3.4 Instrumentation and Control

The information in this section of the reference ABWR DCD, including all subsections, tables, and figures, is incorporated by reference with the following departure.

STD DEP T1 3.4-1

Figure 3.4a Safety System Logic and Control (SSLC) Control Interface Diagram

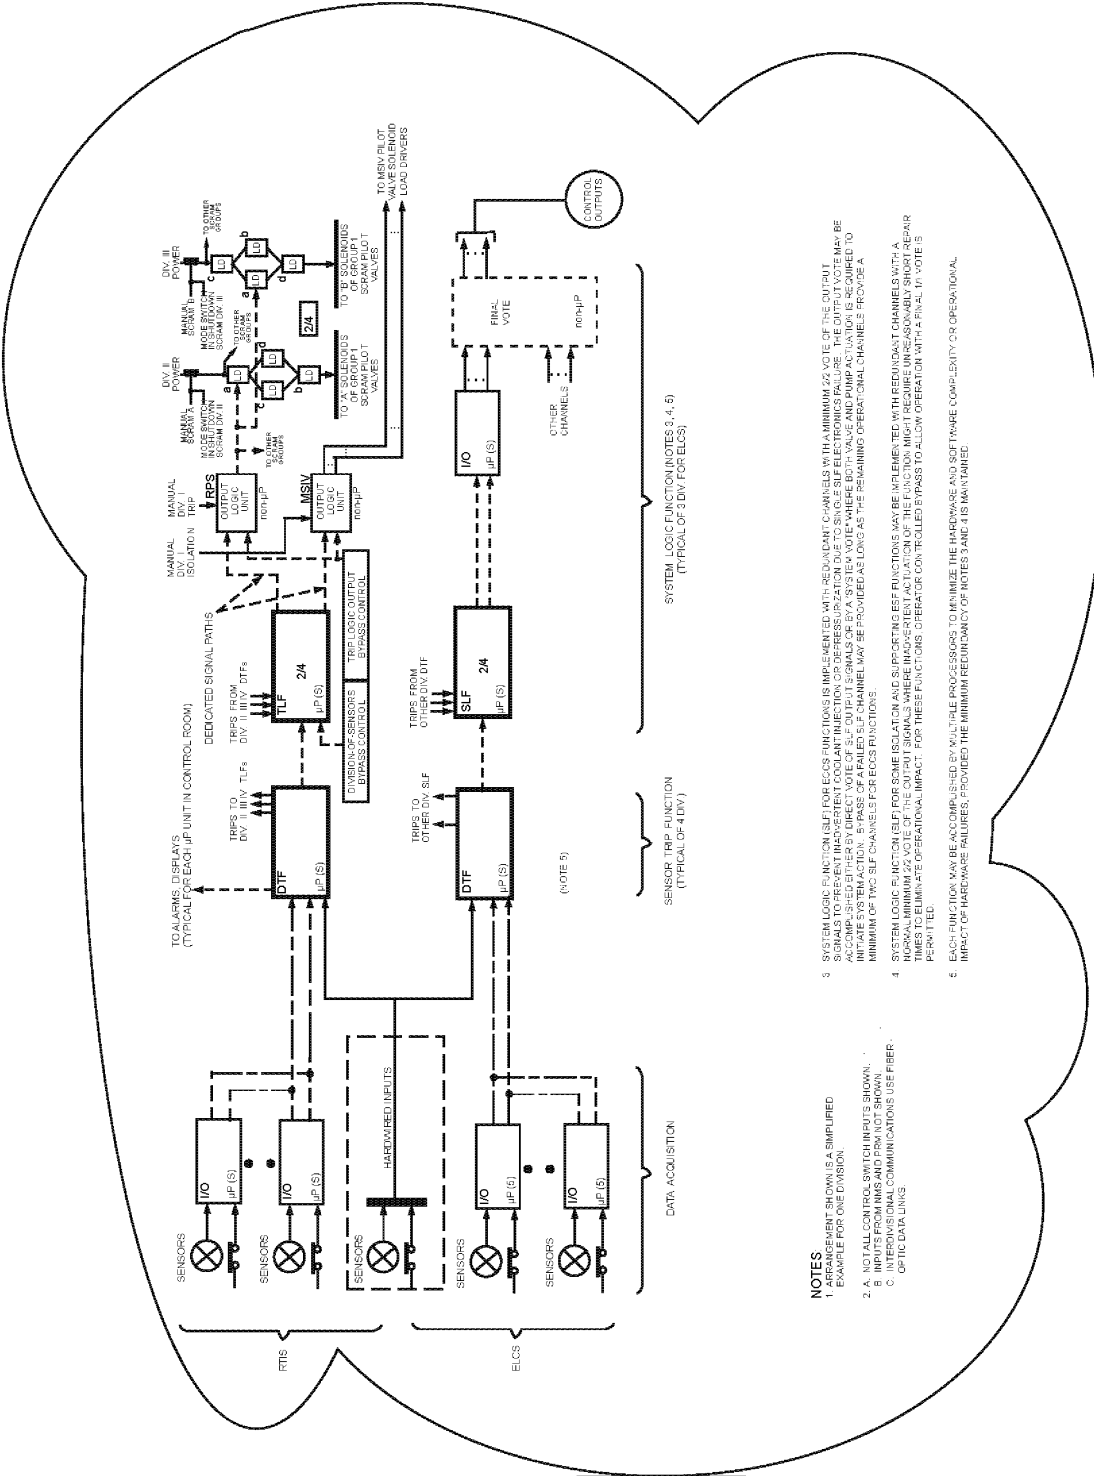
~~Safety-related monitoring and trip logic for the plant protection systems resides in SSLC equipment. SSLC integrates the automatic decision-making and trip logic functions and manual operator initiation functions associated with the safety actions of the safety-related systems.~~ Safety System Logic and Control (SSLC) is a general term that encompasses the logic and controls associated with safety-related systems. This includes automatic and manual protection and control functions. ~~SSLC generates the protective function signals that activate reactor trip and provide safety-related mitigation of reactor accidents.~~ SSLC is primarily implemented through the Reactor Trip and Isolation System (RTIS), which supports the reactor protection and main steam isolation functions, and the ESF Logic and Control System (ELCS), which supports the accident mitigation functions. Also included in SSLC are the Neutron Monitoring System (NMS), the Containment Monitoring System (CMS) and the safety-related portions of the radiation monitoring systems. The relationship between SSLC and systems for plant protection is shown in Figure 3.4a.

Figure 3.4b Safety System Logic & Control Block Diagram

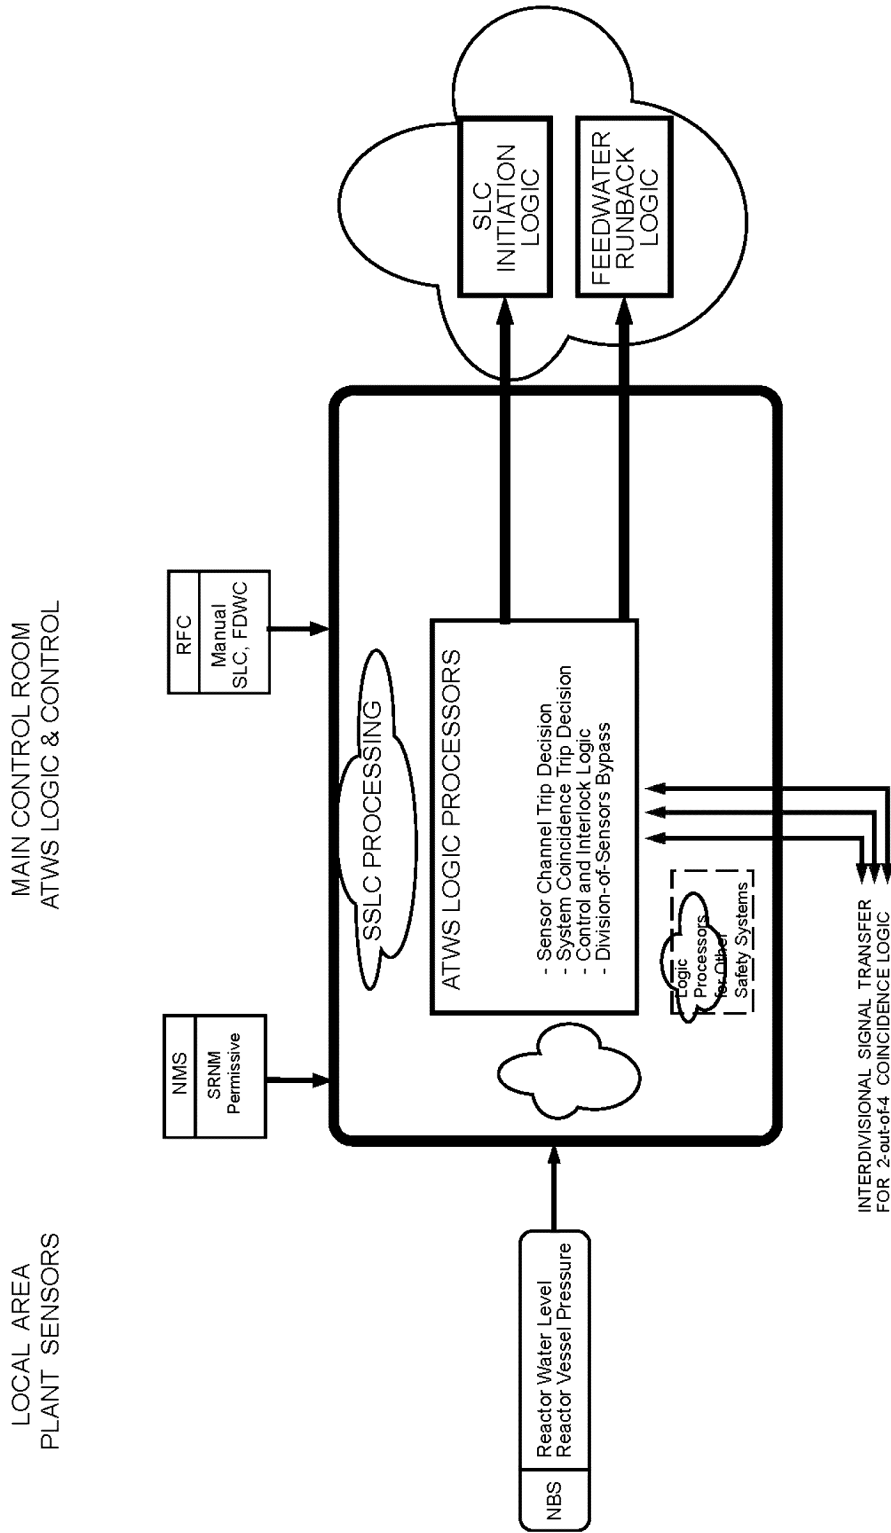
The basic ~~hardware~~functional configuration for one division of SSLC is shown in Figure 3.4b. Each division runs independently (i.e., asynchronously) with respect to the other divisions. The following steps describe the processing sequence and associated function descriptions for incoming sensor signals and outgoing control signals. These steps are performed simultaneously and independently in each of the four divisions:

As shown in Figure 3.4b, a pair of SLU are located in each of two engineered safety feature (ESF) processing channels, ESF1 and ESF2. ESF1 processes initiation logic for functions which service the reactor vessel at low pressure (e.g. RHR), while ESF2 provides the same support for the vessel at high pressure (e.g. Reactor Core Isolation Cooling (RCIC) System and High Pressure Core Flooder (HPCF) System). Associated LDS and ESF functions are also allocated to these logic channels.
